Delegated Report

Householder Planning Application

Planning Application No: 20240570

Location: 11 Court Lodge Shorne Gravesend Kent

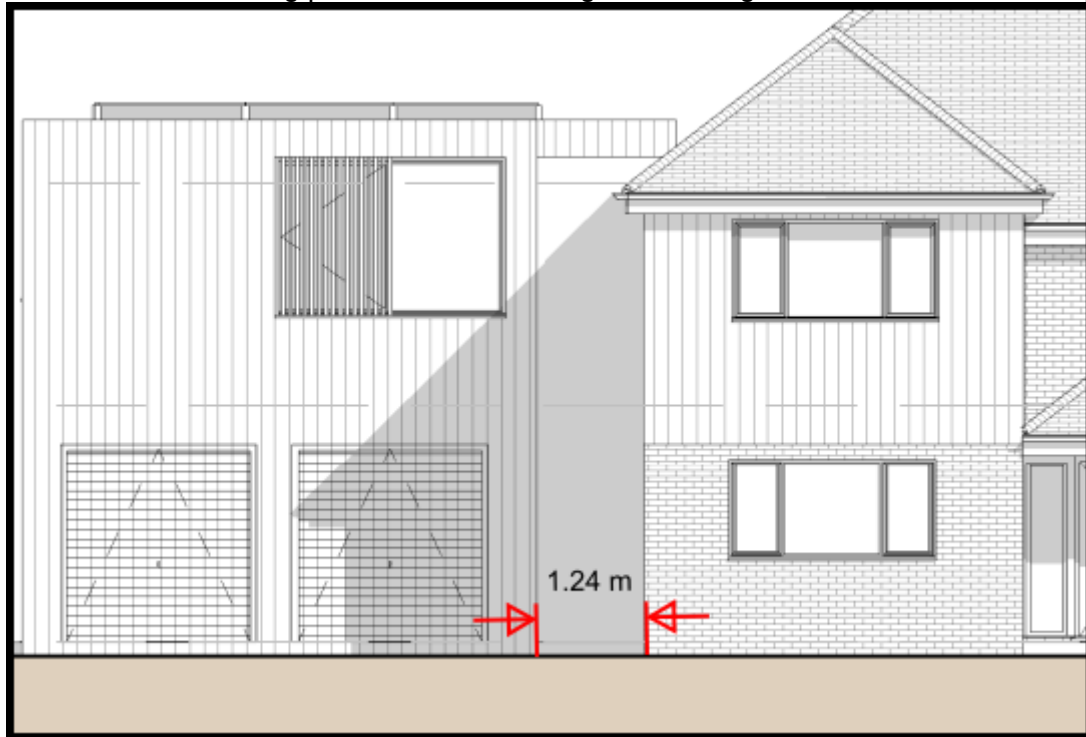
The below front and rear elevations (Not to Scale), shows the proposed two-storey flat roof extension, which would replace the garage. It also shows the single storey pitched extension which would be erected to the west side of the building.

The single storey pitch elevation would be small in scale, with an appropriate roof form. Whilst the door seems somewhat larger than other openings on the front elevation, by itself this would not result in a disproportional or incongruous development.

On the other hand, the flat roof two-storey extension on the east elevation, is a disproportionately sized addition, which would have no features which would reflect the main dwellinghouse. The design would be so incongruous with the existing character of the dwellinghouse and the wider area, such that it would severely disrupt the character of the area were it to be built.

The existing dwellinghouse is 12.7m wide. The proposed side extension to the east elevation would be 7.363m wide and the single storey element to the west would be 2.156m wide. The resulting width of the dwellinghouse would be 22.219m (a 75% increase in the overall width of the dwellinghouse). Whilst, the extensions have been set back in a likely attempt to improve subservience, the encompassing width, and height, which exceeds the eaves of the existing dwellinghouse, would result in an extension which would have a domineering appearance to the main dwellinghouse. The expectation for extensions is that they should be subservient to the main dwellinghouse. This dominating appearance is accentuated further given the highly visible location of the proposed two-storey extension which would front the open driveway.

The flat roof proposed would not reflect the main dwellinghouses, or any other examples of two-storey development in the area. The existing dwellinghouse uses its roof form and pitches at either end of the building to portray a somewhat symmetrical appearance, which would be destroyed by the introduction of a two-storey flat roof. Flat roofs at two-storey level are consistently resisted as they appear unnecessarily bulky, with harsh roof lines, and non-descript appearances, which are not characteristic of the suburban area.

The use of fenestration to all elevations of the proposed extension has no positional or size relation to the main dwellinghouse. They are set higher and are significantly larger in size and number. To the rear, there is no spacing between windows. Yet to the front elevation there is a 1.24m wide blank section of wall which appears at odds as the connecting point between the original dwellinghouse and the extension proposed.

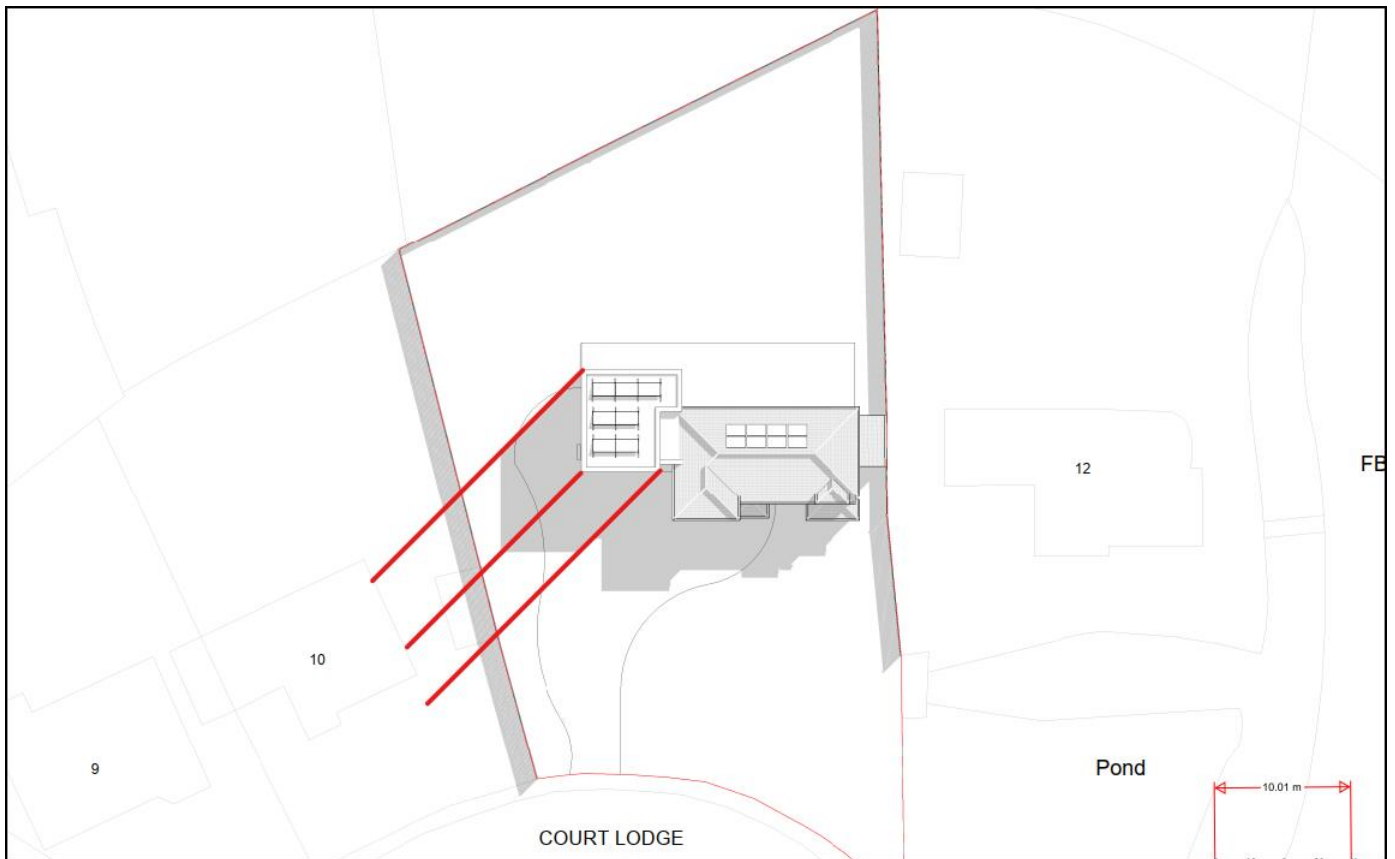
There are 2 properties which adjoin the subject dwellinghouse; 10 Court Lodge to the east and 12 Court Lodge to the West.

To the east elevation, the only change would be the single storey element, which would by its very nature, not result in any significant overshadowing. Not would any new openings be created in this elevation. As such, there would be no overbearing impact on 12 Court Lodge.

To the West elevation, the proposal would remove the existing single storey garage and a two-storey extension would be built. So there is potential for overshadowing to 10 Court Lodge. There would also be an additional ground and first floor window introduced to this elevation. At ground floor level there would be no direct overlooking. At first floor level, given that the window would serve an ensuite, it could be reasonably required to be obscured by planning condition, to prevent harmful overlook.

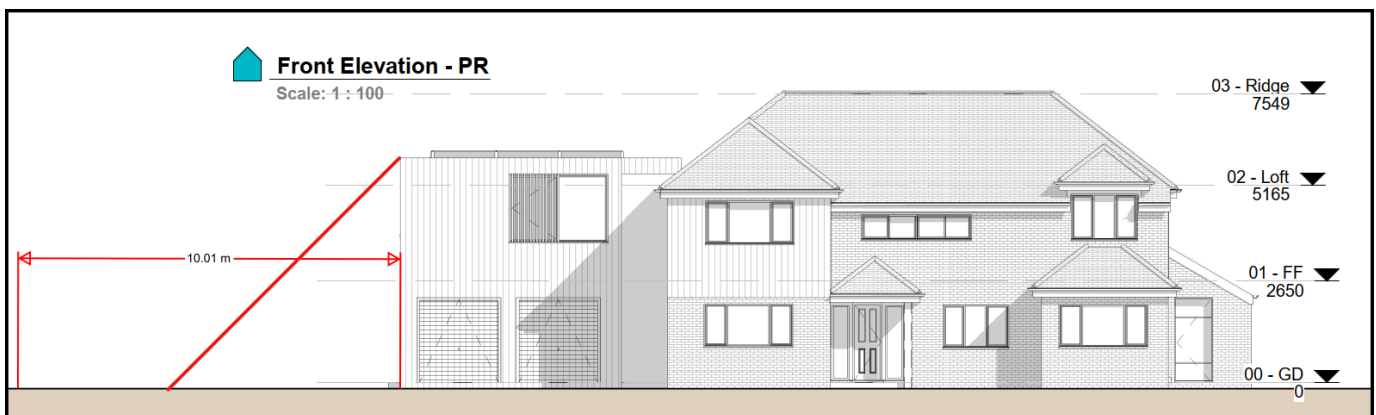
AS the below 45 degree test shows, given the positional relationship between the buildings, the proposed two storey extension would potentially overshadow the windows on this neighbours side elevation.

There is an approximate distance of 16m between the dwellinghouses. As the below elevational, 45-degree test shows, the proposed building would not result in shadowing which extends to 16 metres wide of the existing dwellinghouse. Therefore, overshadowing of this neighbours' windows is unlikely to occur.
